Variation 3 – Taiwawe Catchment Structure Plan – supplementary s42A

I provide my response to S42A authors comments by Elisabeth Resl dated 9 September 2021.

Figure 1: S Map Online – Displaying a range of soil types as expected given the change in slope and elevation from ash to alluvial deposits

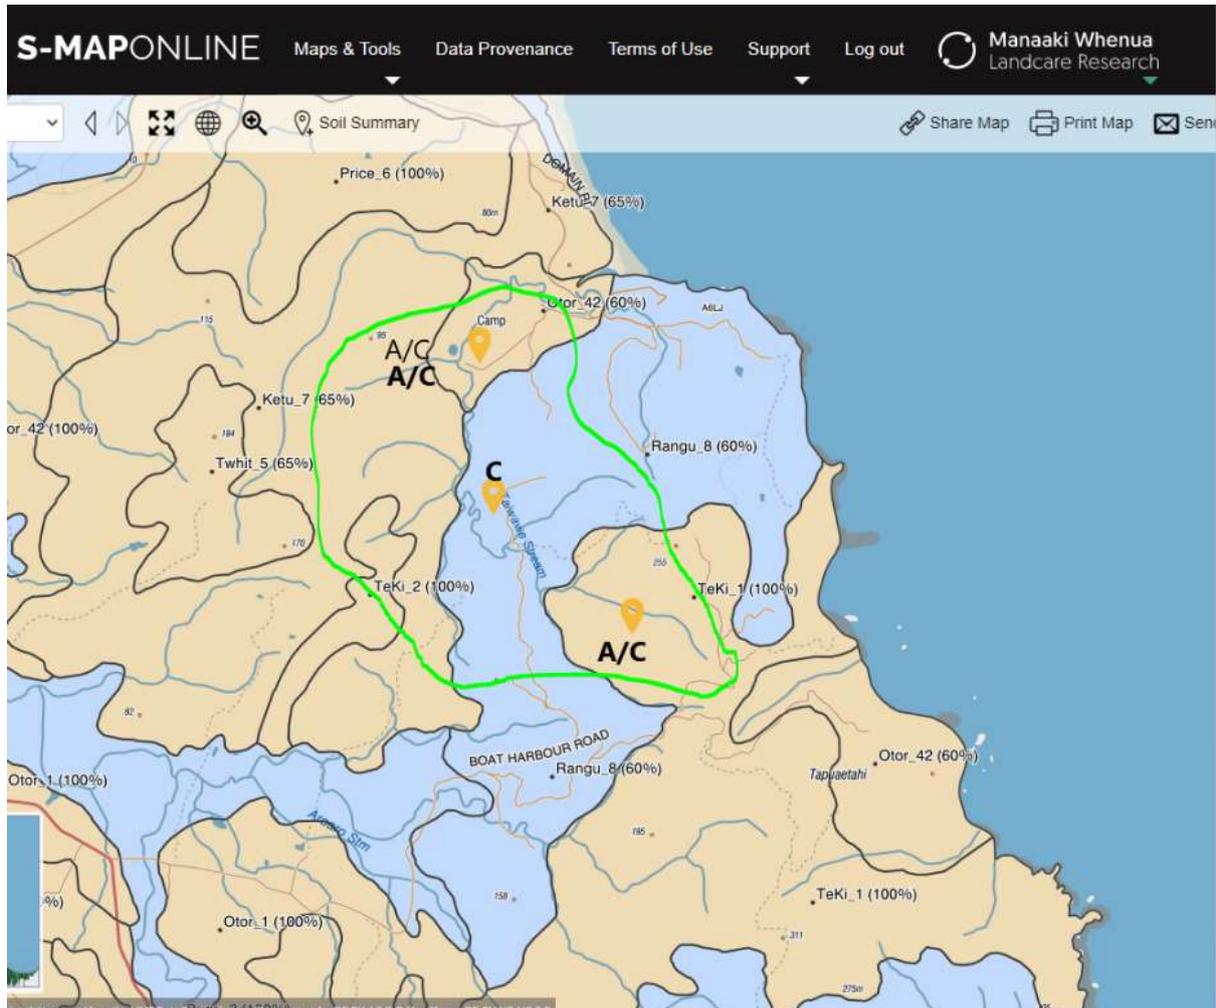
b. Landcare research S-Map for this catchment (Figure 1) shows a range of soil types from Soil type A (more permeable) through to C (less permeable) which is consistent with Mr Kelsey’s evidence which essentially describes different soils on site transitioning from alluvial flats up into hill country ash deposits overlaying weathered ignimbrites. I used Soil type B (midway between the range of values shown in s map). Soil type B is not inconsistent with Mr Kelsey’s evidence as supported by ‘Point 21 Ground Conditions’ which states ‘favourable drainage for hill country’ with well-developed stiff clay and silt soils. Typically, on moderately sloping hills well-structured ash soils can display good drainage at the surface. The ‘moderate to slow drainage’ statement by Mr Kelsey is related to AS/NZS 1547 wastewater guidelines and is not directly applicable or transferable to assessing soil type hydrological groups impacting runoff.

I note S Map is not highly accurate and should always be supported by site testing where available. So, there are arguments both ways for whether to adopt B or C or indeed A in some places. However, I agree there is merit in using Soil type C and for the avoidance of doubt, I have also undertaken an assessment of peak runoff using Soil type C. I have found the peak flows are still less for the post development scenario compared to the existing landuse irrespective of whether soil type B or C is used.

Figure 2: HEC HMS hydrograph based on catchment wide model - the existing site catchment = 38ha (catchment 3 grey line) compared to the larger Taiwawe catchment (catchment 1 blue line) and adjacent catchment (catchment 2 orange line).

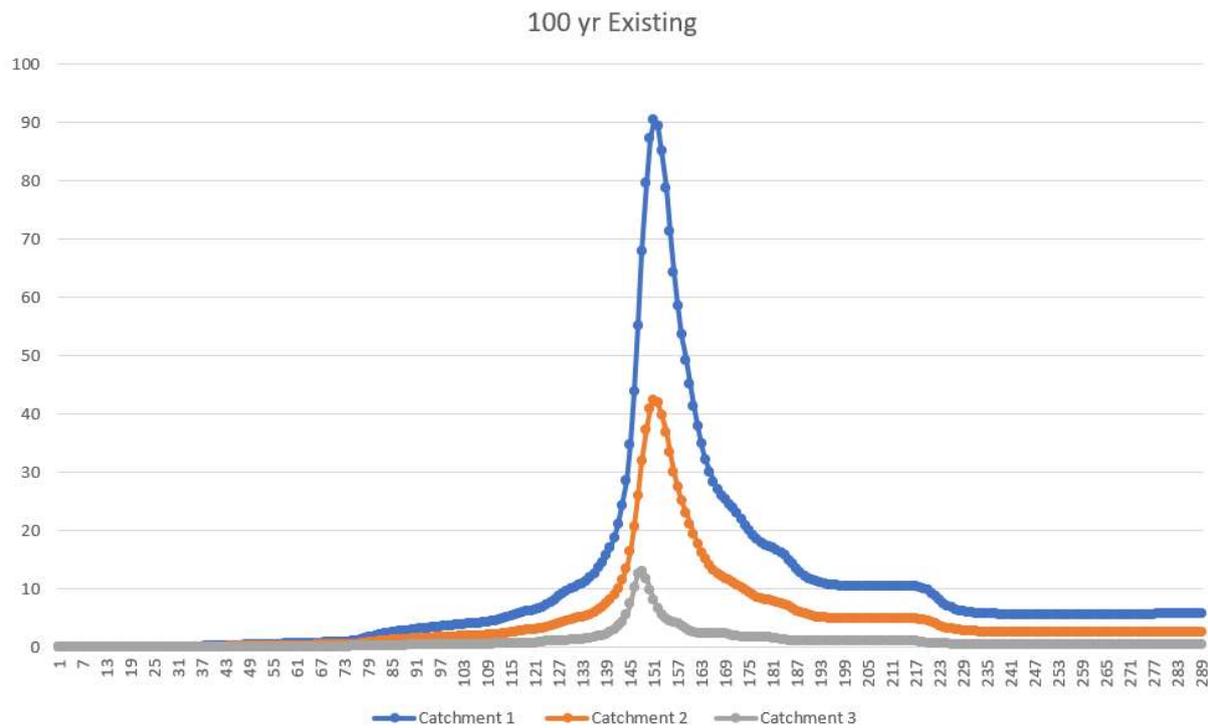
Figure 2 shows peak flows from the 38ha site arriving earlier at the outlet compared to the Wider Taiwawe Catchment and western catchment. This is expected given the shorter time of concentration and location lower in the catchment. The HEC HMS model highlights the significant difference in peak flows arriving from the wider catchment area compared to the site.

Figure 3: Is for the site only (Catchment 3) Hydrograph shows the post development flows (orange) are lower than the existing flow (blue) due to the re-vegetation and slowing of runoff.

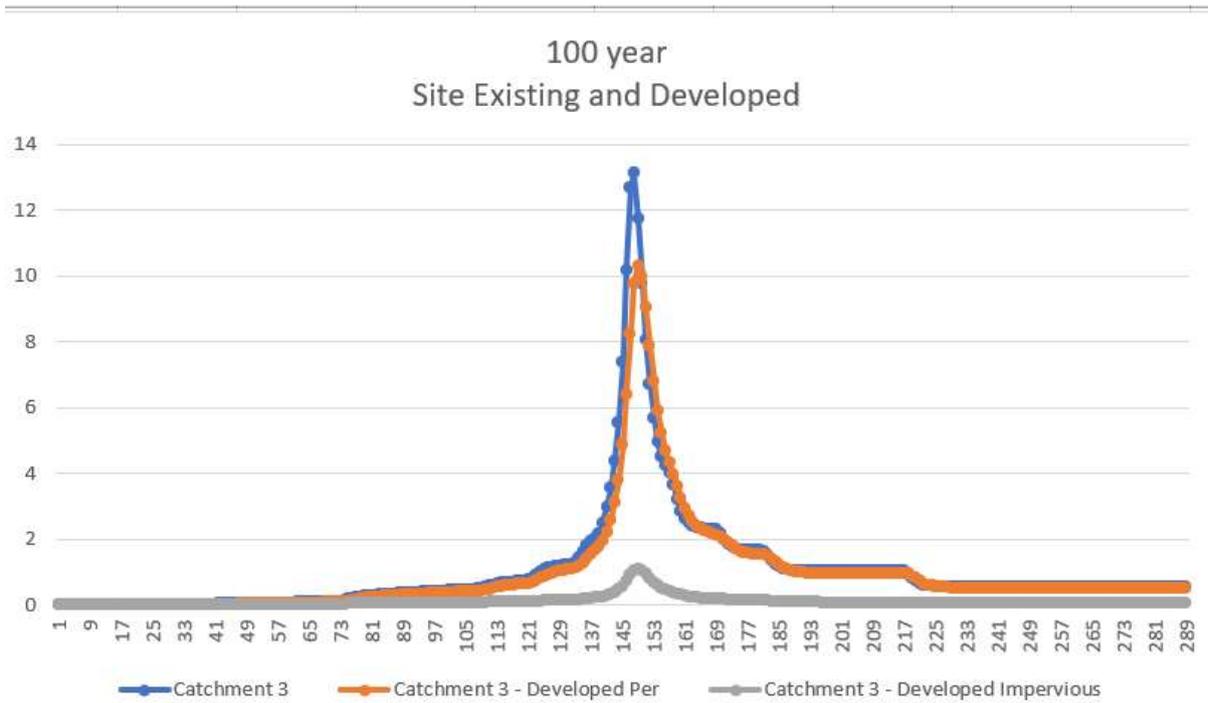
The HEC HMS model shows peak flow hydrograph are reduced for the developed scenario and also show the smaller peak from the site arriving at the outlet point slightly earlier than the main peak from the larger catchment. The time of concentration from the larger 'catchment 1' is ~45minutes compared to the time of concentration for Taiwawe in the order of 20minutes.
